MAINE TURNPIKE AUTHORITY

ADDENDUM NO. 1

CONTRACT 2025.03

Pavement Rehabilitation and Safety Improvements and Pipe End Repairs
MM 51.2 TO MM 54.5

PAVEMENT REHABILITATION
AND SAFETY IMPROVEMENTS
PAVEMENT CRACK REPAIR
AND BERM CORRECTION DETAILS

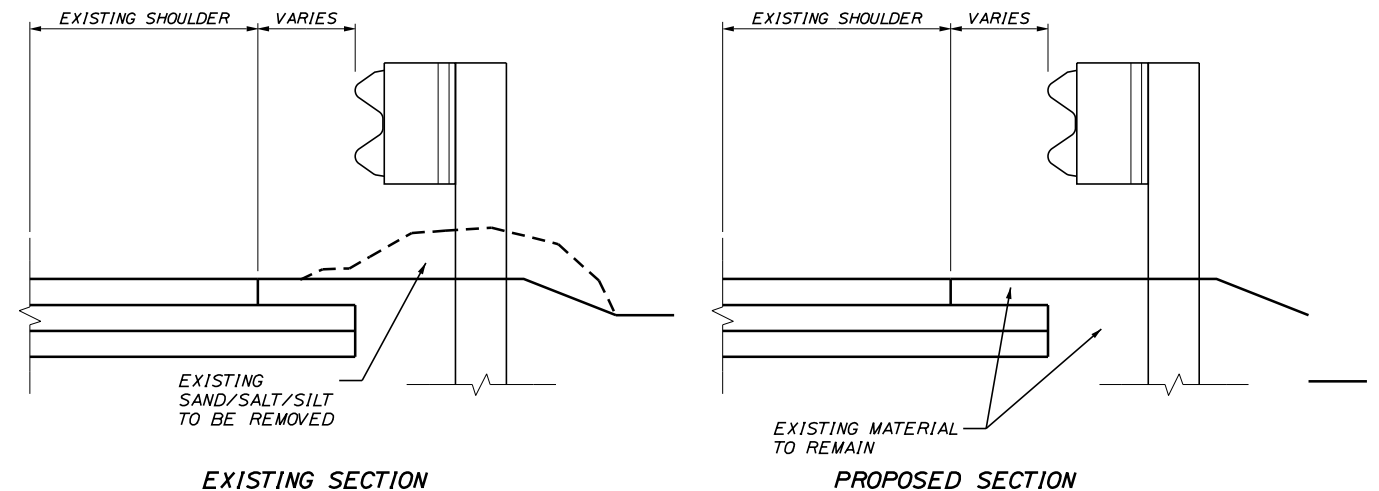
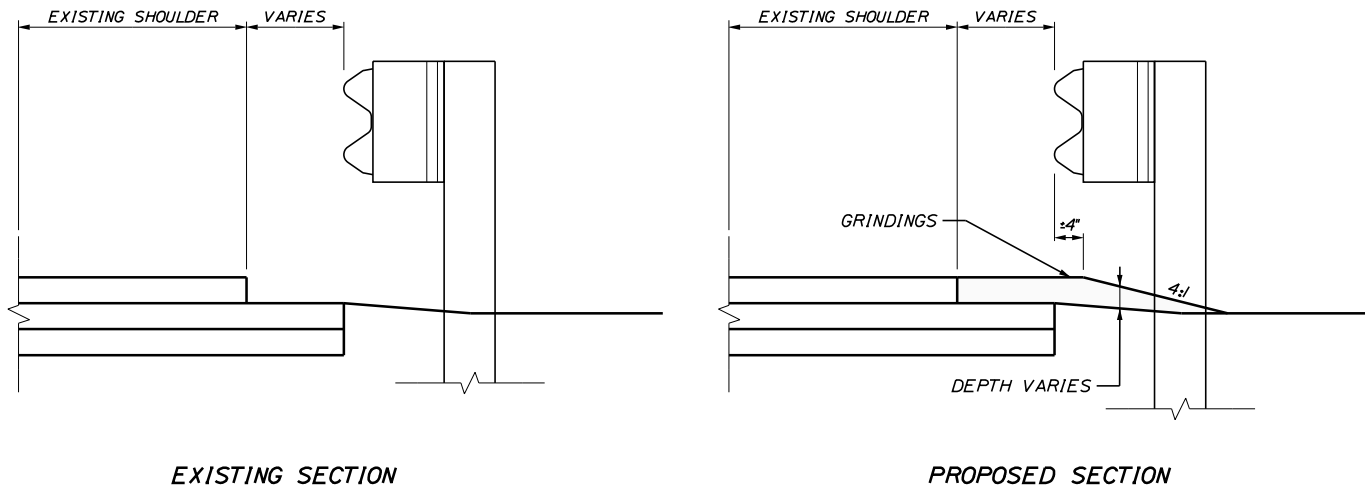
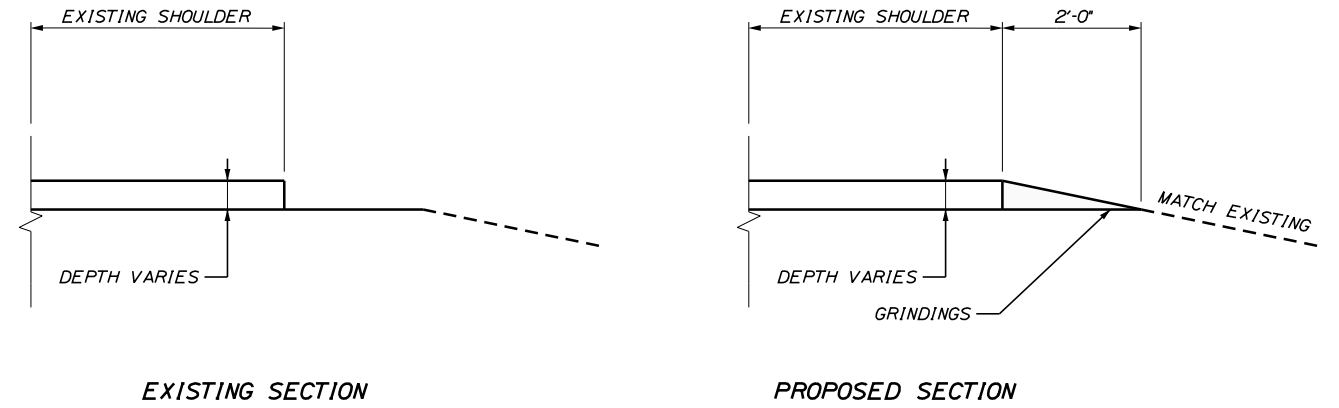
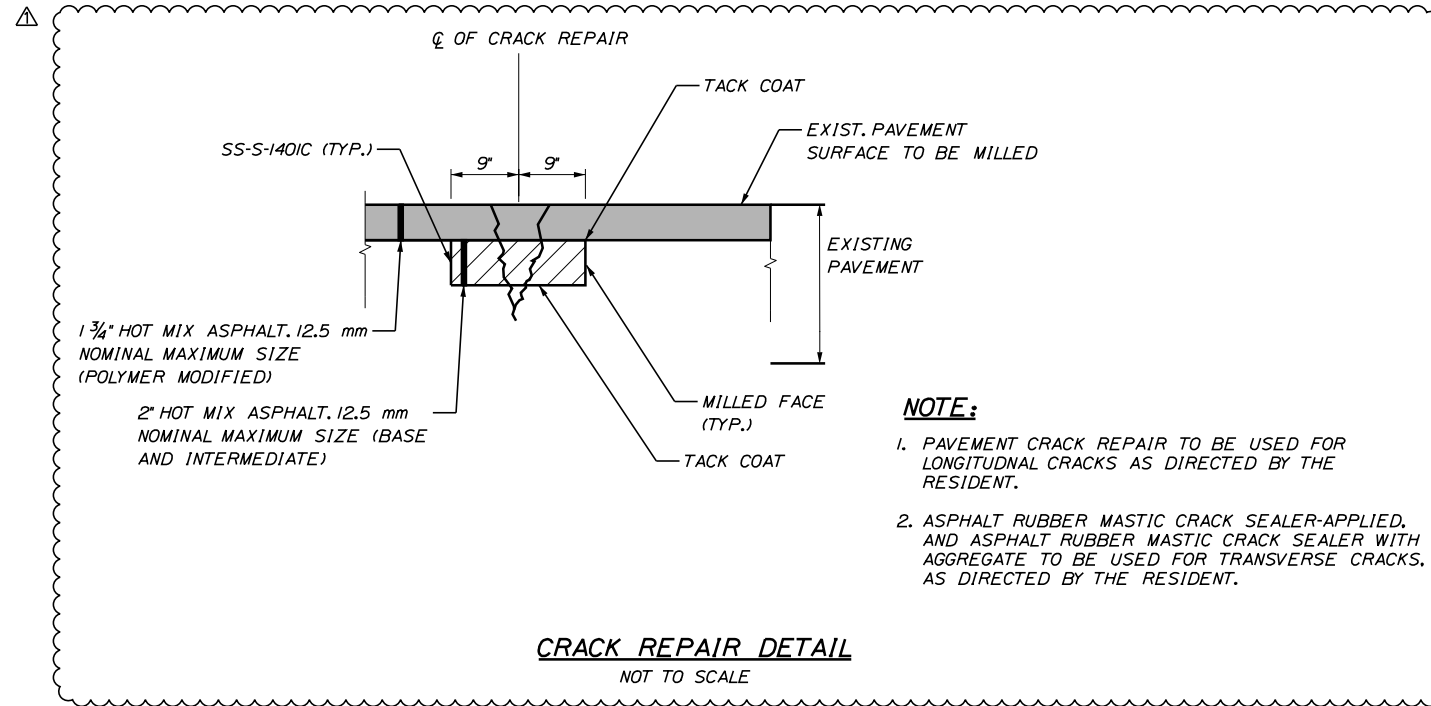
Answer: The intent is to use the Asphalt Rubber Mastic Crack Sealer-Applied, or Asphalt Rubber Mastic Crack Sealer with Aggregate for transverse cracks. A note has been added to the Crack Repair Detail in the plans to clarify.

Scale: NOT TO SCALE			
No.	Revision	By	Date
1	REVISED CRACK REPAIR DETAIL	NJB	1/2025
